TOWN OF LOS GATOS
PARKS AND PUBLIC WORKS

PROJECT INFORMATION SHEET
Engineering Division
July 1, 2019

**ITEM: 16 Chestnut Avenue; APN: 510-40-012
Architecture and Site Application S-17-047**

Requesting approval for demolition of an existing pre-1941 single-family residence and construction of a single-family residence on property zoned R-1:12.

Figure 2: driveway section detail as included on sheet C6 of the project plans

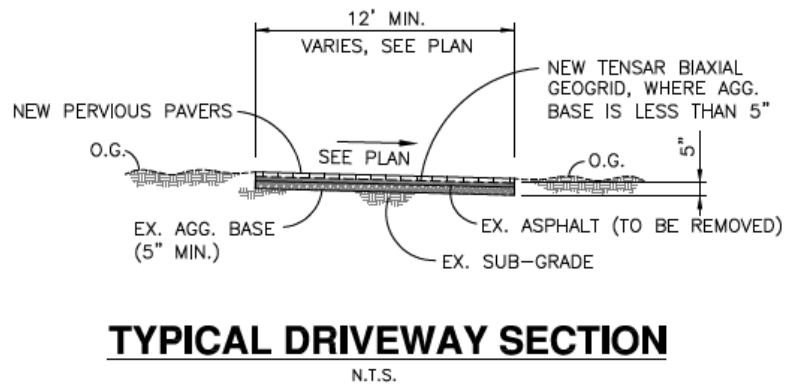
It should be noted that the Town Consulting Arborist Recommendations, included on page T-1 of the project plans, states “All paver installation within 50 feet should be above the existing soil surface with only minor

scarification to even out the grade under the existing asphalt.”

scarification to even out the grade under the existing asphalt.” The plans propose permeable pavers in the location of the existing asphalt, which require specific subbase materials in order to allow infiltration of stormwater into soils, which contrasts with the existing aggregate base as referenced in the project plans on sheet C6 (see Figure 2 above and Figure 3 at left).
